## SUPPLEMENTAL REPORT

### EVALUATION OF GROUNDWATER FLOW FOR LOT 387 ON ASSESSOR'S MAP 9 ALSO DESIGNATED AS SEA LEA COLONY LOT 121 CHARLESTOWN, RHODE ISLAND

## SUPPLEMENTAL REPORT Number 2

# EVALUATION OF GROUNDWATER FLOW FOR LOT 387 ON ASSESSOR'S MAP 9 ALSO DESIGNATED AS SEA LEA COLONY LOT 121 CHARLESTOWN, RHODE ISLAND

Figure 1. Site Development Plan for Lot 387 Showing Location of Cross-Section A-A

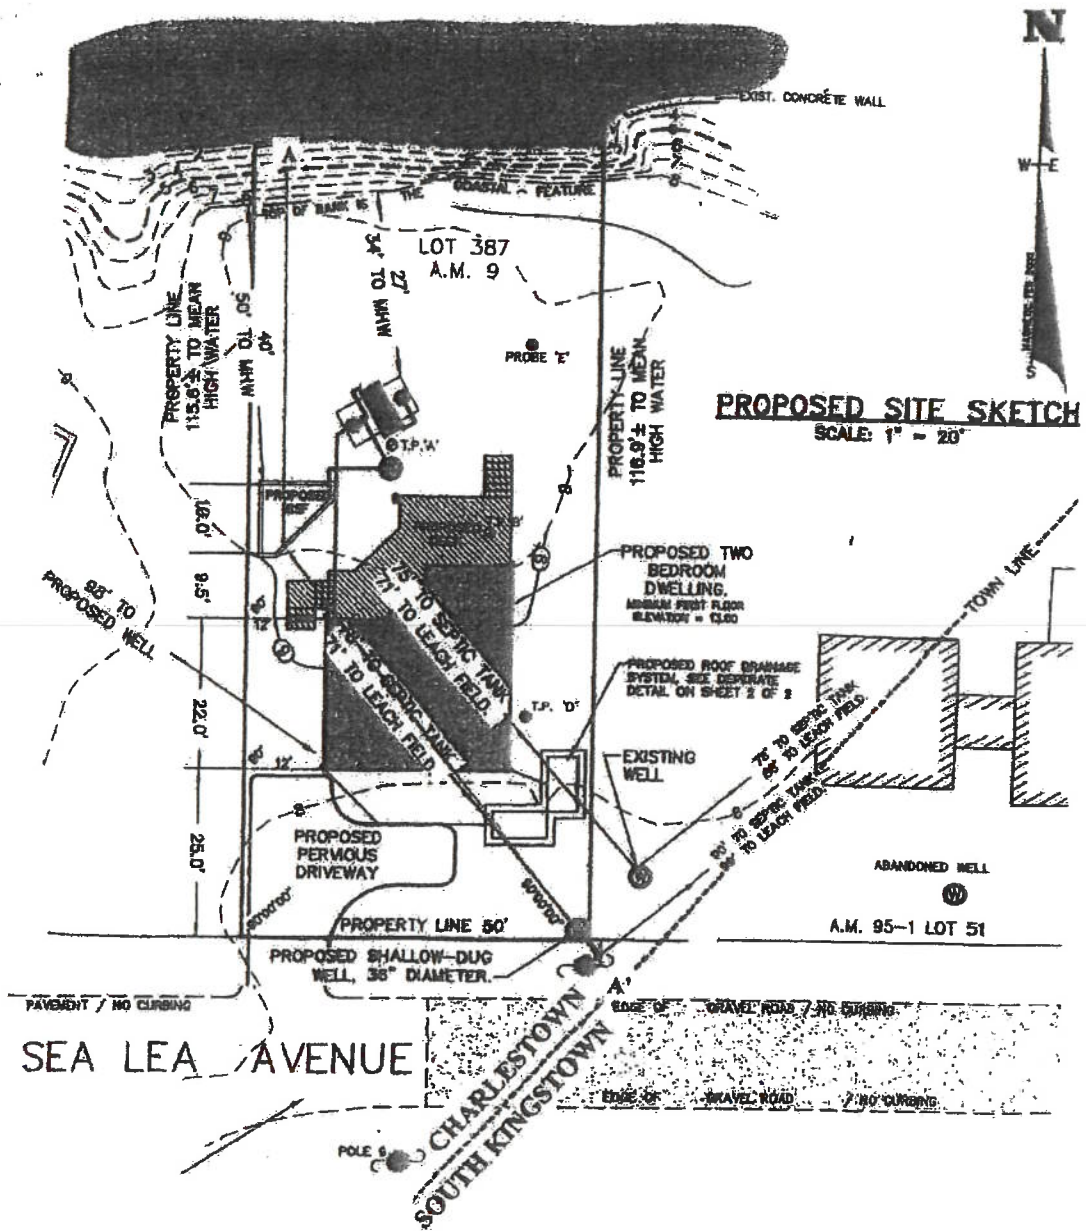
- c) The location of the leach field is now 71 feet to both the existing and the proposed drinking water wells, as compared to the previous distance of 62 feet to the nearest well.

- d) The location of the septic tank is now 75 feet to the existing well as compared with the previous distance of 60 feet.
  - e) The proposed individual sewage disposal system (ISDS) will be used only for "grey water". The toilet sanitary wastes will be handled by a separate composting system.

The revised site plan is attached herewith as Figure 1.
